MEMORANDUM

SUBJECT: BZA Case 19127 – SUPPLEMENTAL REPORT - variance and special exception relief to allow a subdivision and construction of 10 flats at 2800 Sherman Avenue NW

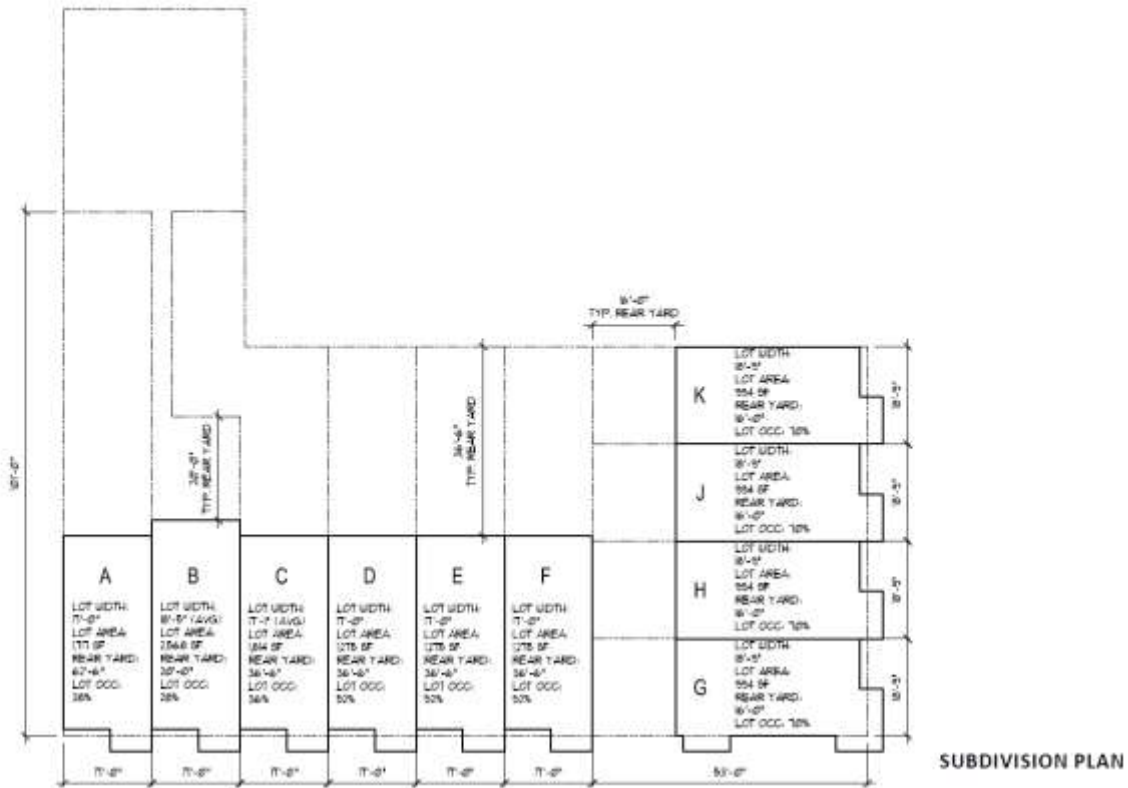
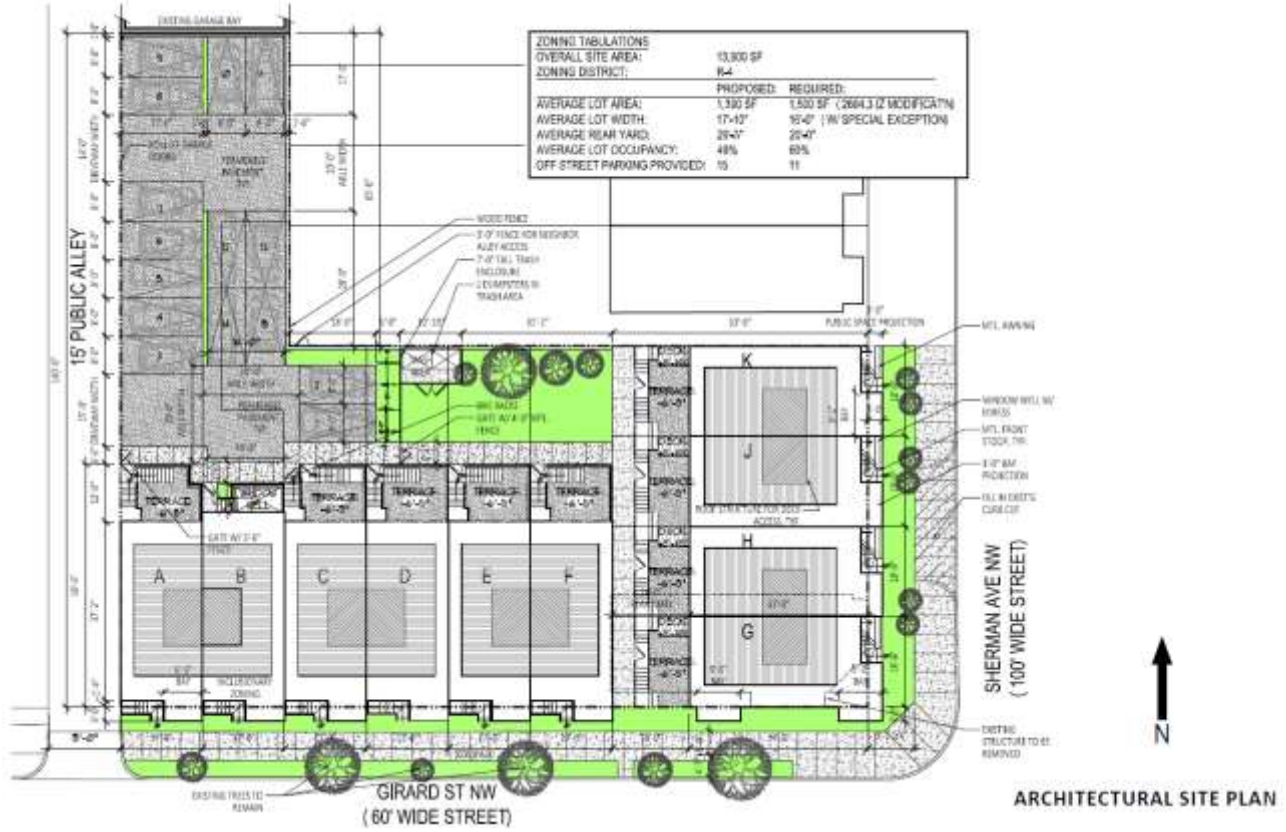
In response to a request by the Board at the conclusion of the public hearing on December 8, 2015, 2800 Sherman, LLC (the “Applicant”) submitted to the Board additional information on January 26, 2016. The Applicant’s revised proposal includes a revised site plan with one lot eliminated from Sherman Avenue (10 lots instead of 11, or 20 units instead of 22 units), as shown on Sheet 5 of the revised architectural plans and elevations (Exhibit 40). Further, the Applicant proposes removing one of the two proposed trash areas after further consultation with a trash contractor, and there is now one trash area in the center of the site with larger bins/dumpsters for trash and recycling than previously proposed. In addition, the flat containing the IZ units would now be located on Girard Street (Lot B) instead of on Sherman Avenue.

The proposal would still result in the need for variance and special exception relief for the development, including a special exception for the proposed penthouses, but the degree of relief has been reduced. Nevertheless, the Office of Planning’s concerns remain regarding the nexus between the Subject Property’s exceptional situation and the practical difficulty of developing the site. There does not appear to be a practical difficulty related to the shape of the lot that, as a new lot subdivision, would prevent it from being developed in conformance with the intent of the Zoning Regulations. Although the Office of Planning is supportive of the revised architecture as generally consistent and compatible with the surrounding community, **OP cannot support** the following variance relief and will be prepared to further address the Applicant’s revised proposal at the continued public hearing on February 2, 2016:

- § 401.3 Lot Area (1,500 square feet min. required; 994 – 2,568 square feet or an average of 1,390 sf. per lot proposed);
